# COP8CBR/CCR/CDR9 User Information Sheet Rev. I

This user information sheet is intended to aid users of all revisions of the COP8CBR9/CCR9/CDR9 series of products by documenting known problems and limitations of the C revision of this device and of product documentation for the device.

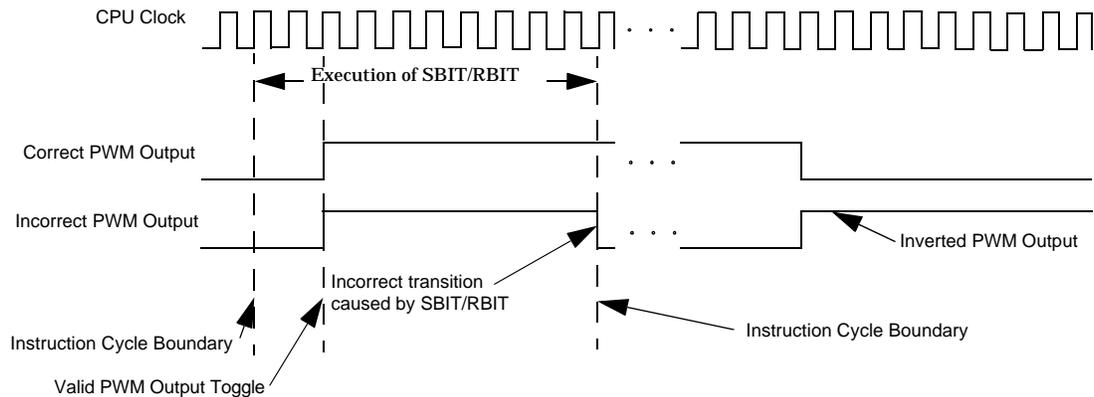
Description: If either Timer T2 or T3 is used in High Speed PWM mode and an SBIT or RBIT instruction operates on any other bit of the PORT L Data Register, the PWM output may **appear** to miss a toggle and thus be inverted. If the timer causes the PWM output to toggle in the middle of an SBIT or RBIT operation on the PORTLD Register, the PWM output may be set back to its state

before the output toggle by the operation of the SBIT/RBIT. This can have the effect of generating a shortened pulse (less than one instruction cycle in width) on the PWM output and inverting the PWM duty cycle.

If the PWM Timer is used in low speed mode or if the PWM output toggle is synchronous with the end of the instruction cycle, this problem is not seen. The following figure illustrates the PWM output when the failure is seen.

The user should be aware of the state of Timers T2 and T3 before any SBIT or RBIT instructions are executed which operate on the PORTLD register. If the PWM output is close to toggling, the user should delay the SBIT or RBIT instruction.

The following program sequence works to delay the operation. The user may wish to experiment with other sequences to see which best fits the application and to make sure that the time between the completion of the tests and the modification of PORTLD is not too long. The sequence can easily be modified to work with Timer T3.
